HISTORIC AND DESIGN REVIEW COMMISSION
March 03, 2021

HDRC CASE NO:	**2021-078**
ADDRESS:	1815 FREDERICKSBURG RD
LEGAL DESCRIPTION:	NCB 1929 BLK 36 LOT 1-A EXC NW TRI 16 FT AND SE TRI 5 FT
ZONING:	C-2, H
CITY COUNCIL DIST.:	7
LANDMARK:	Individual Landmark
APPLICANT:	Jacob Valenzuela/Deco Pizzeria
OWNER:	Jacob Valenzuela/OFFSPRING CAPITAL INVESTMENT LLC
TYPE OF WORK:	Patio cover
APPLICATION RECEIVED:	February 08, 2021
60-DAY REVIEW:	Not applicable due to City Council Emergency Orders
CASE MANAGER:	Huy Pham

The applicant is requesting a Certificate of Appropriateness for approval to construct a new metal patio cover structure.

GFR Development
Lone Star Awning
2711 Fredericksburg

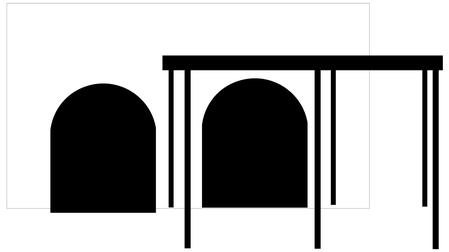
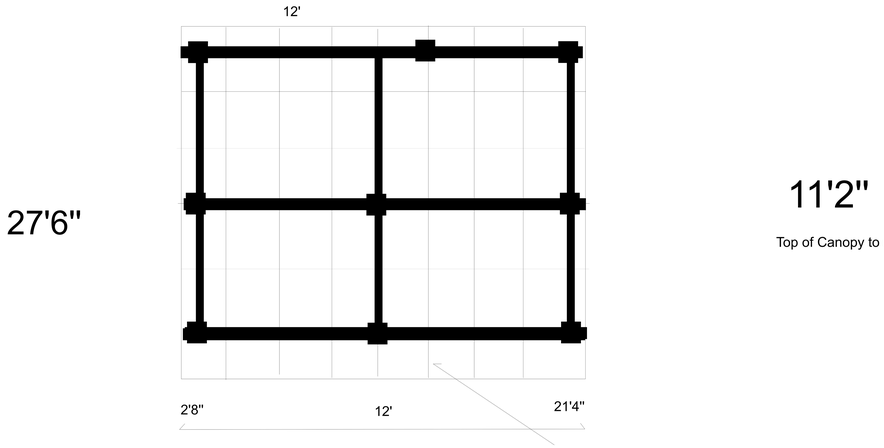
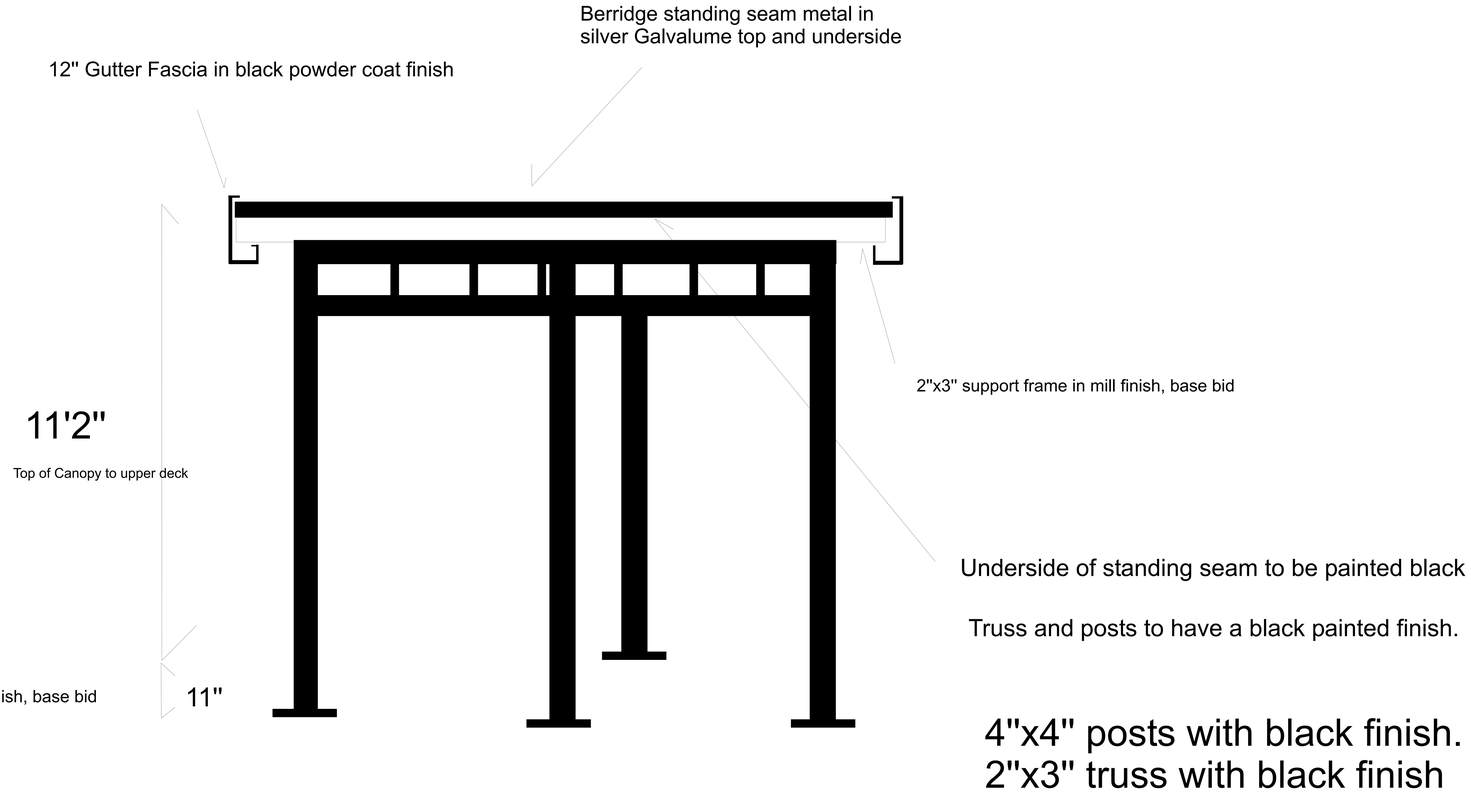
c. PATIO – The applicant has proposed to install a 24’ by 26’6” patio cover with black metal construction and a galvalume metal roof, adjacent to the arched window to the northeast corner facing Fredericksburg. The site previously features a non-original wood patio cover which would be removed. Per the Guidelines for Exterior

Maintenance and Alterations 11.B.ii., if no such evidence exists of a historic canopy or awning, the design of new canopies and awnings should be based on the architectural style of the building and be proportionate in shape and size to the scale of the building façade to which they will be attached. Staff finds that the black metal construction relates to the existing site elements and storefront fenestration system and is appropriate. Additionally, staff finds that the proposed structure should remain freestanding and does not contact or obscure the arch window and parapet it is adjacent to.

RECOMMENDATION:
Staff recommends approval based on finding c with the stipulation that proposed structure should remain freestanding and does not contact or obscure the arch window and parapet it is adjacent to.
